Subject: Optional compressor fill cap – dipstick assembly.

Unit/Part Affected: CP48301 booster compressor

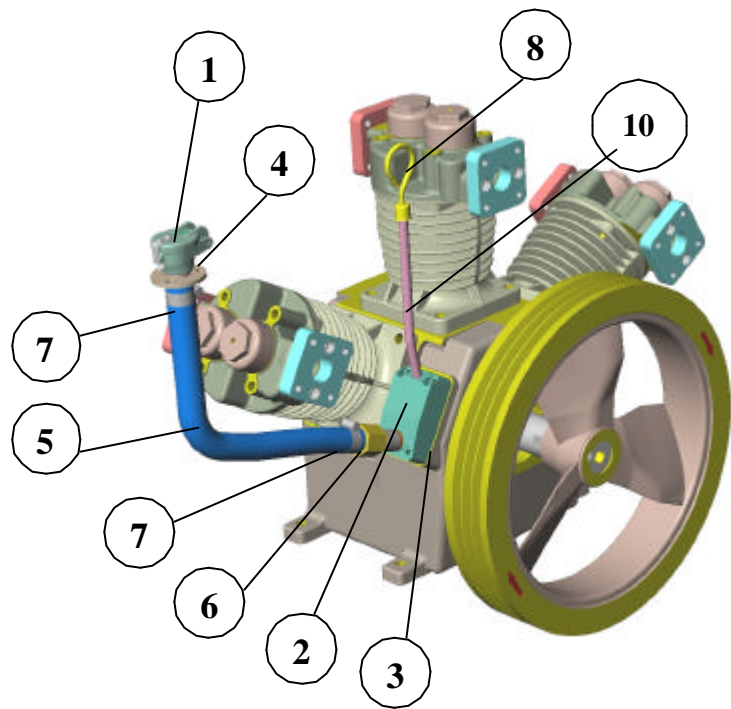
Cubex has developed an optional fill cap – dipstick assembly for the CP48301 booster compressor. The modifications to the crankcase housing to accept the assembly will be made by Cubex on new compressors and during the rebuilding of existing compressors.

The new assembly for convenience will include a new flexible hose routed crankcase vent and fill cap. This will allow the filling of crankcase lubrication from any selected position as long as the slope is maintained to the compressor sump.

An oil level dipstick stick is also integrated into the retrofit adaptor block.
